Regional Joint Development Assessment Panel Agenda

Development Description: Proposed Composting Facility
Applicant: Planning Solutions
Owner: Thi Chinh Duong, Van Phy Doan & Van Tiep Doan
Responsible Authority: Shire of Gingin
DAP File No: DAP/23/02467

**LOT 800 AND 801 MILITARY ROAD, MUCKENBURRA
PROPOSED MUSHROOM COMPOSTING FACILITY
AMENDED DEVELOPMENT PLANS AND FURTHER INFORMATION – JDAP DEFERRAL RESPONSE**

Date - 07.08.23
Design - CPH
Drawn - MDB
Checked - CPH
Scale - 1:600
Job No. - 0830
Dwg - DA02
Rev - E

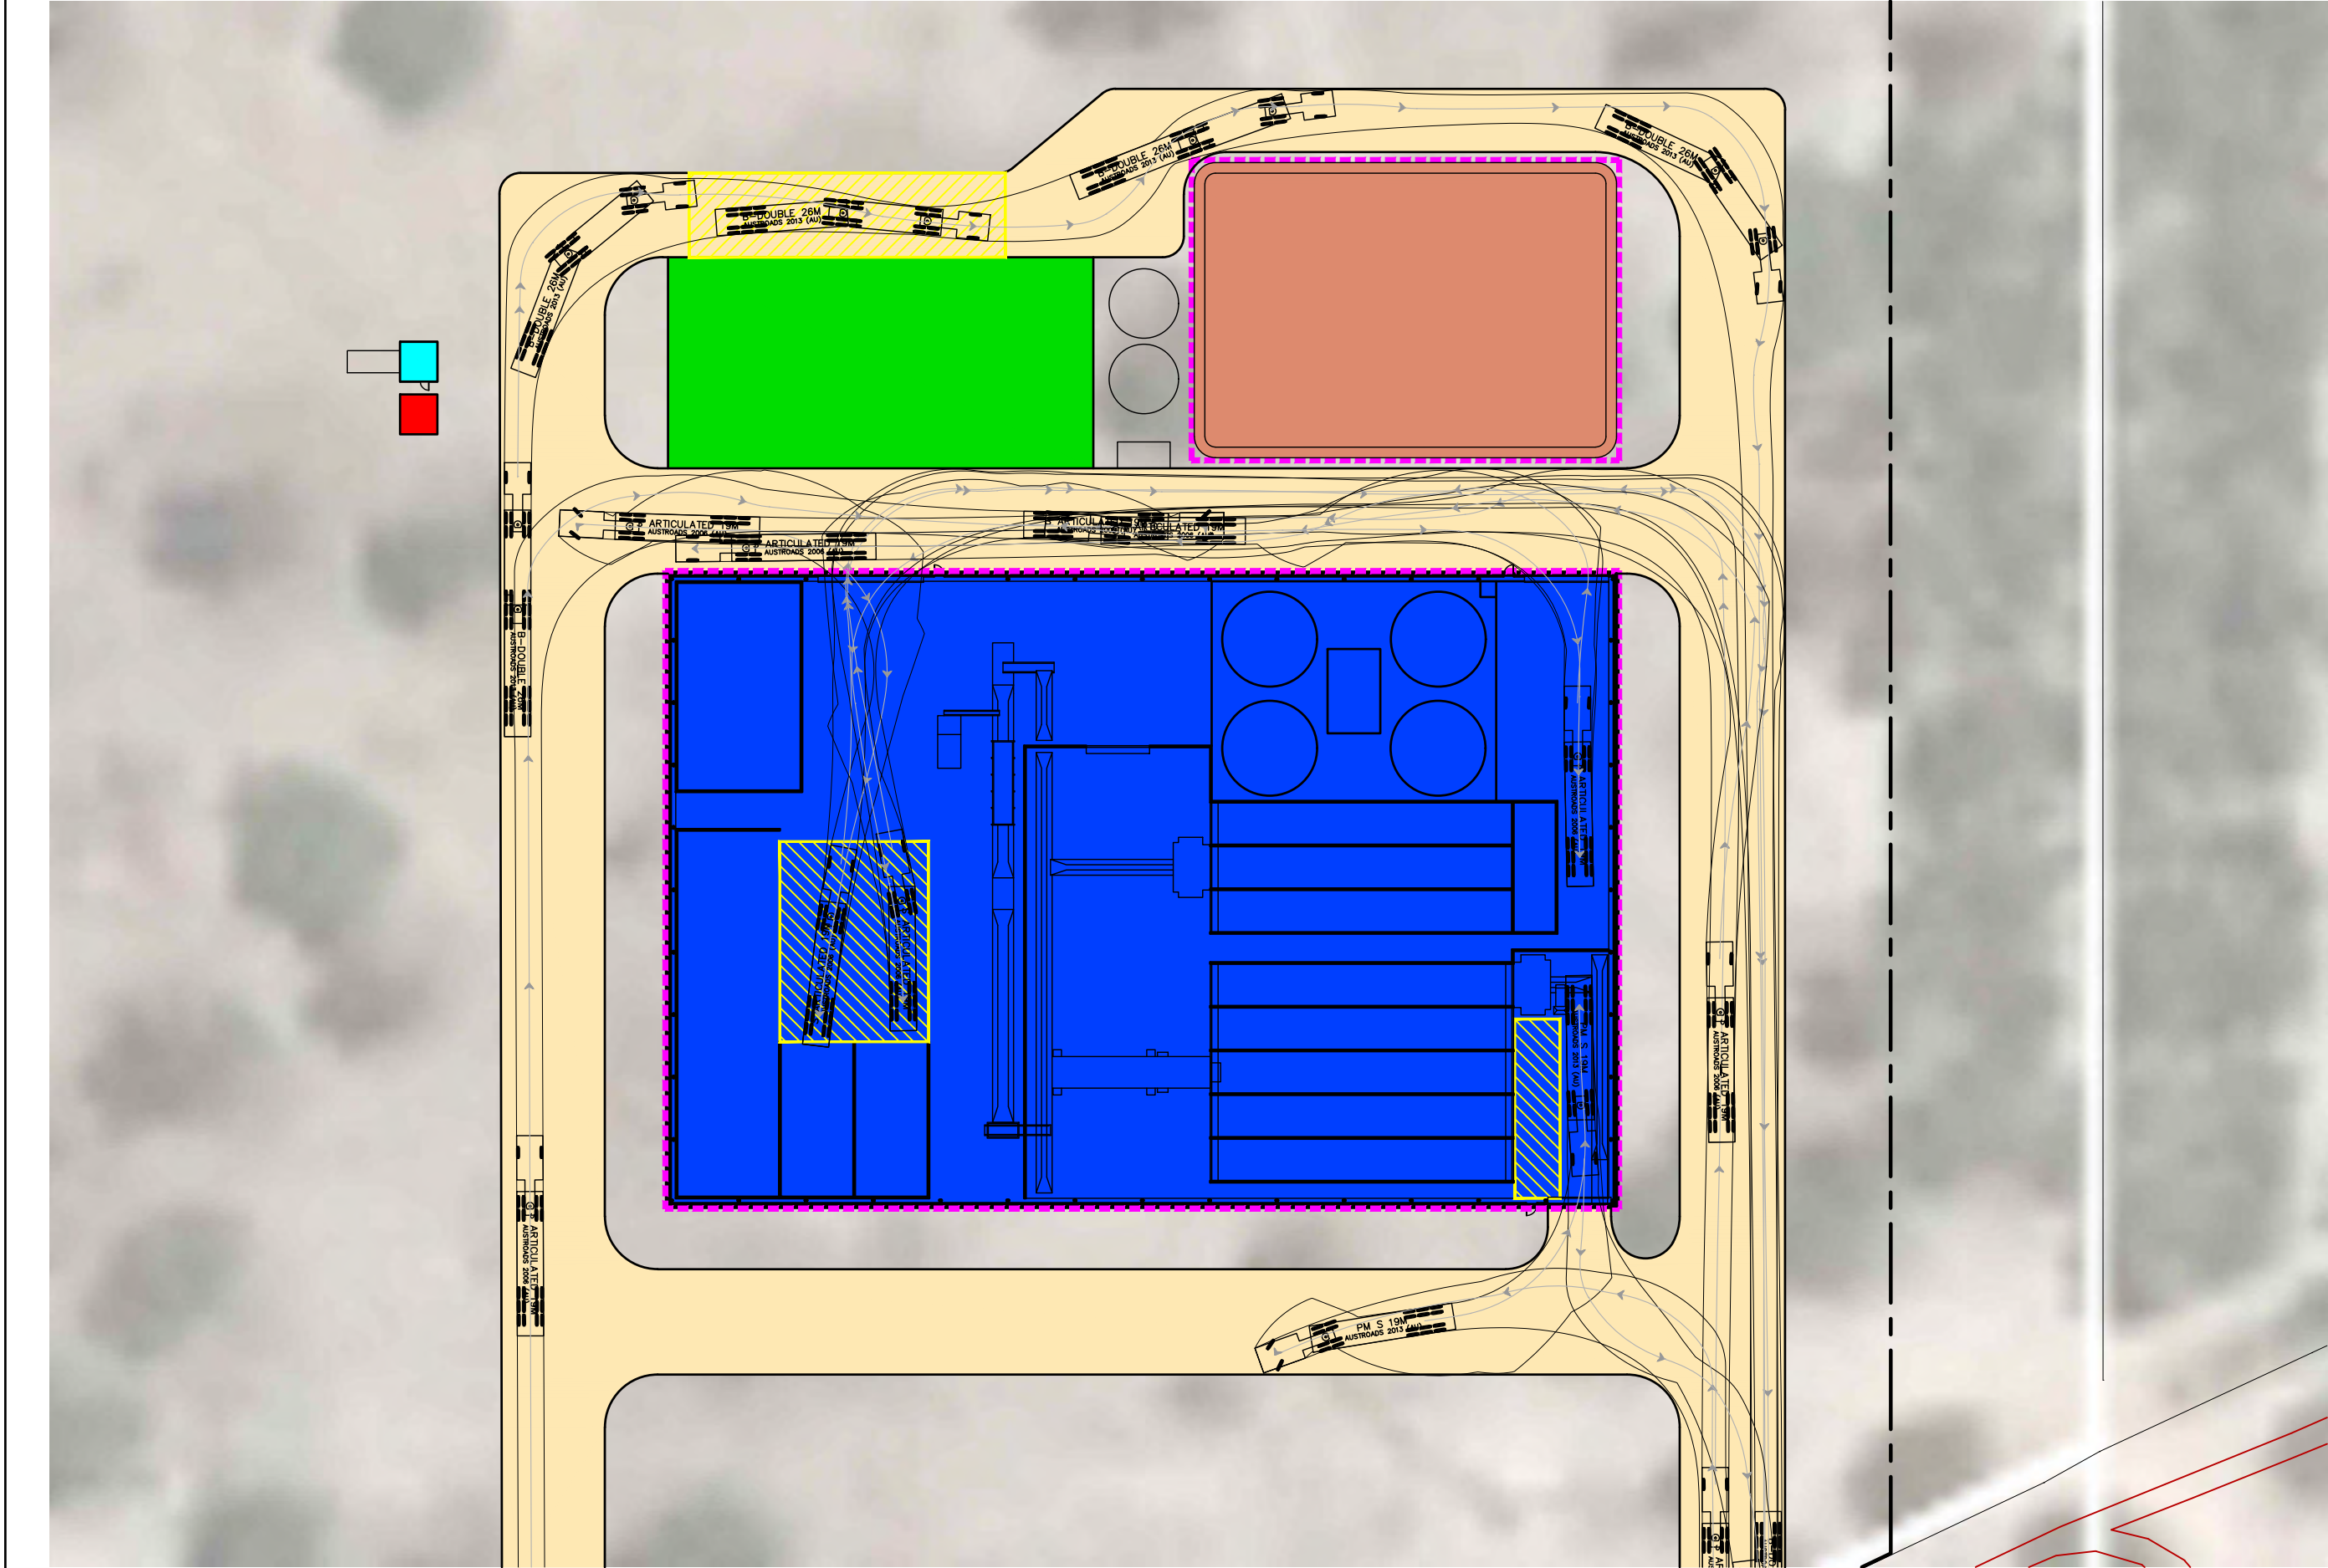
- b. *The development plans do not accurately depict the wastewater pond (delineated as 'rain overflow pond') or provide elevation drawings that outline the capacity, design or lining of the infrastructure.*

- c. *The development plans do not demonstrate the location for the loading/unloading of heavy vehicles within the confines of the composting building.*

- Additional detail shown on the proposed site plan, including an underlay of the proposed floor plan on the footprint of the Mushroom Composting Facility building and revised footprints of the wheat straw bale storage area and rainwater/rain overflow pond.

- Revised crushed/compacted limestone access road layout and widths. The central road has been widened to 10m (formerly 8m) and the northern road realigned and narrowed.

- Revision of some access locations on the proposed site plan, with entry/exit doors to the facility reconfigured.
- The inclusion of a site truck path plan, depicting the suitable access, egress and turning movements of a B-Double truck (delivery of wheat straw bales) and 19m semi-trailers (unloading of poultry manure and gypsum and loading of compost).

Figure 2 - Gingin Crossover Standard Drawing

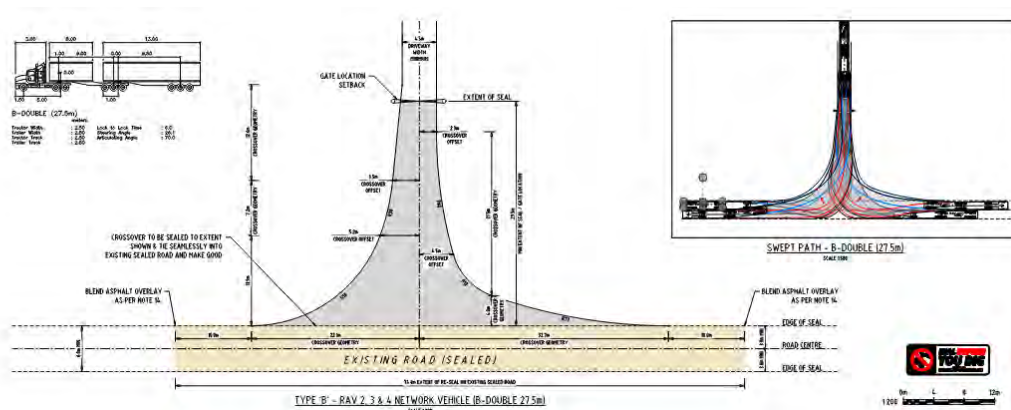
The design of the crossover should be in accordance with the Shire of Gingin's *Rural & Industrial Crossover Fronting Sealed Road Heavy Vehicles per Week: >5 to ≤10* (2021) standard drawing, shown in **Figure 2**, and AS2890.2 *Parking facilities Part 2: Off-street commercial vehicles parking* (2018). Under these, it is acceptable for B-Doubles and Semi-Trailers to use the opposite lane of travel to utilise the crossover. Rigid Trucks and Light Vehicles must be able to use the access lane-correct.

Based on the standard crossover design shown in **Figure 2**, the centreline of the upgraded crossover should be relocated a minimum of 38.7m north of the prolongation of the Chitna Road reserve boundary. This would require a realignment of the access track within the property to tie-in to the new crossover location.

Figure 3 - Prohibited Locations of Access Driveways

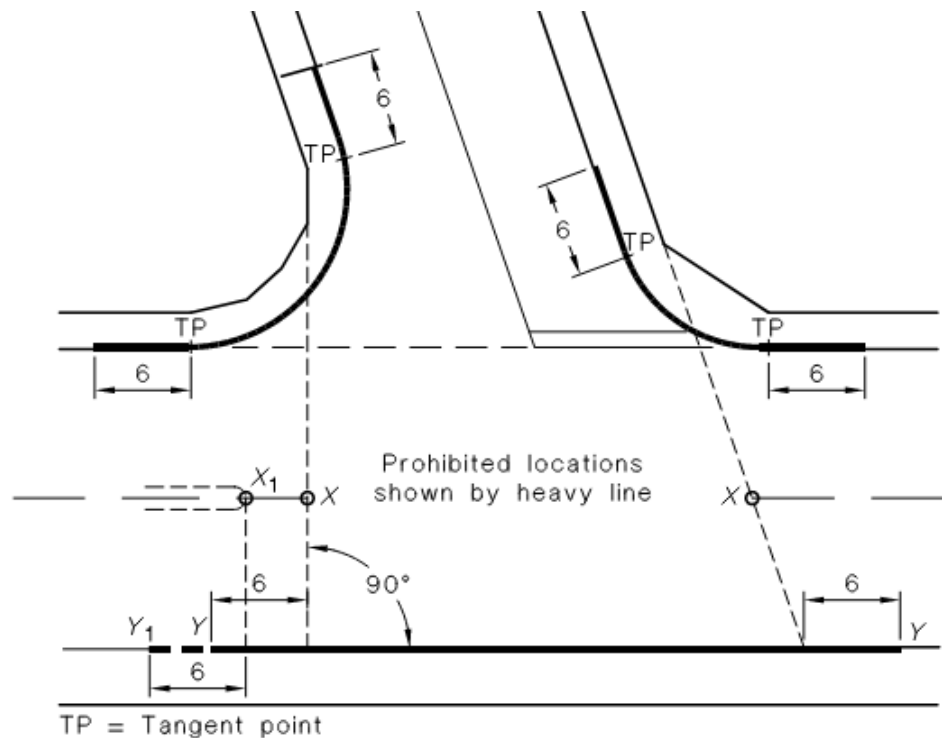
The proposed access location of the Mushroom Composting Facility is on Military Road adjacent Chitna Road. Commercial property accesses can cause unacceptable traffic conflicts with frontage road traffic if located too close to an intersection, therefore, Section *AS2890.1 Parking facilities Part 1: Off street car parking* (2004) prohibits the provision of commercial property accesses near unsignalised T-intersections as depicted in **Figure 3**.

As the precise location of the road reserve boundary on Chitna Road is unclear, an estimate of the approximate area of access prohibition is shown in **Figure 3**. It is evident that the existing access location is not compliant with Australian Standards.

Figure 5 - Sight Distance Requirements at Access Driveway Exits

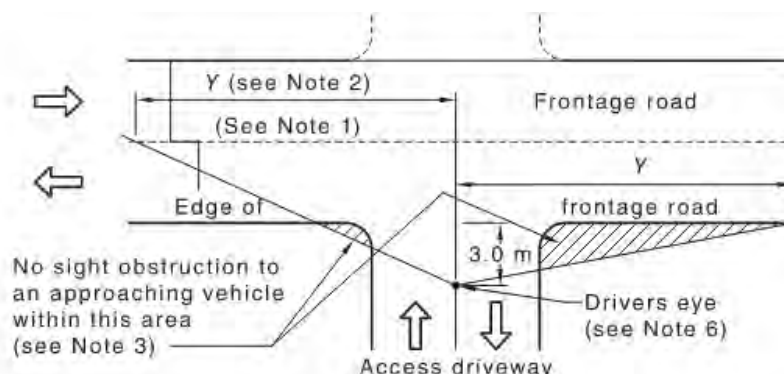
AS2890.2 Parking facilities Part 2: Off-street commercial vehicle facilities (2018) lists the sight distance requirement for a crossover onto a 90km/h road as 125m as per **Figure 5**. The speed limit of 90km/h has been adopted given the only 85th percentile speed in the area is close to Gingin Brook Road which for which the speed data is distorted by the nearby intersection (i.e. well below 90km/h).

It should be noted that while the sight distance value of 125m may be suitable for light vehicles entering a 90km/h road, it may not be suitable for heavy vehicles entering the same road. Heavy vehicles take significantly longer to execute the turning movement and this presents a higher risk of conflict occurring, particularly where it is necessary for heavy vehicles to cross to the 'wrong' side of the road when exiting the crossover. As per *Austroads Guide to Road Design Part 4A: Unsignalised and Signalised Intersections* (2023) Section 3.4, "desirably, sight distances at accesses should comply with the sight distance requirements for intersections". Therefore, assuming a 2% downgrade on each approach, it is recommended that Safe Intersection Sight Distance (SISD) of 221m be provided, based on *Austroads Guide to Road Design Part 4A: Unsignalised and Signalised Intersections* (2023), Table 3.2 and Table 3.3.

Based on a desktop assessment, SISD is likely to be available from the south, however it may not be achieved to the north due to the horizontal curve. This should be resolved during the detailed design of the crossover.

Figure 6 - Restricted Access Vehicle Network

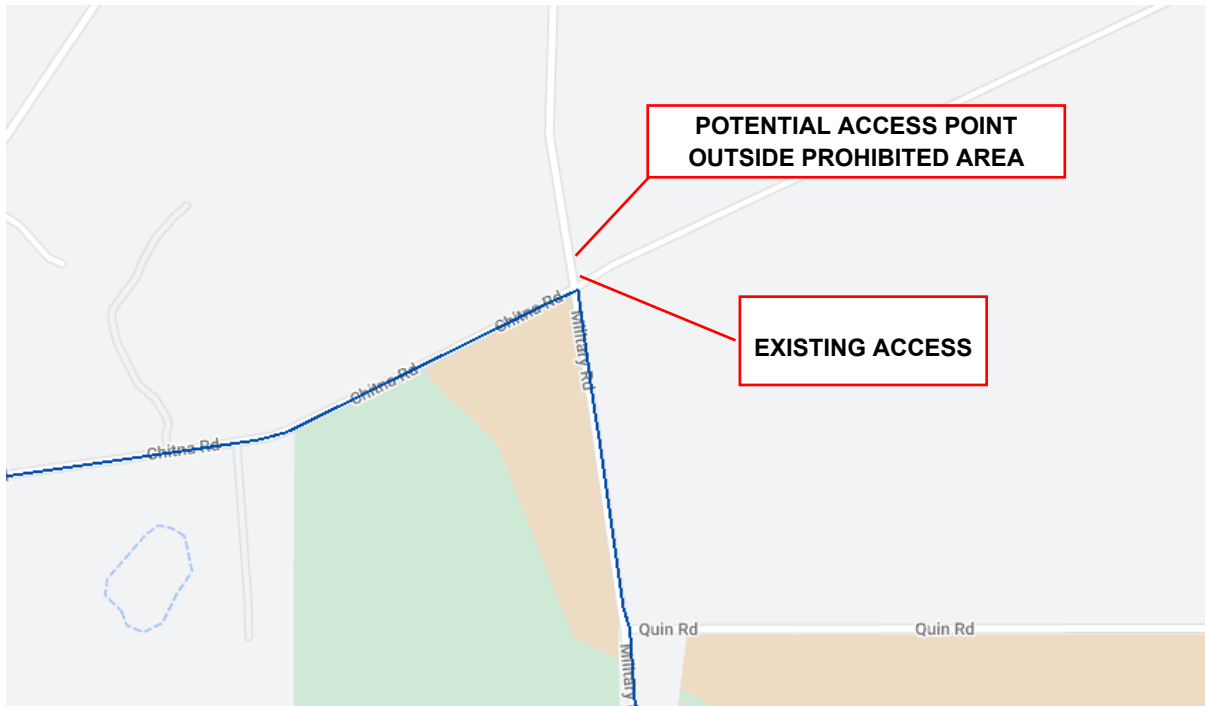
Whether in the existing location or further north, the access appears to be slightly outside the existing RAV network shown in **Figure 6**.

To facilitate B-double access to the proposed development, as described in their *Development Application Report* (2023), then a minor amendment to the RAV 4 network will be required to ensure the access abuts the network.
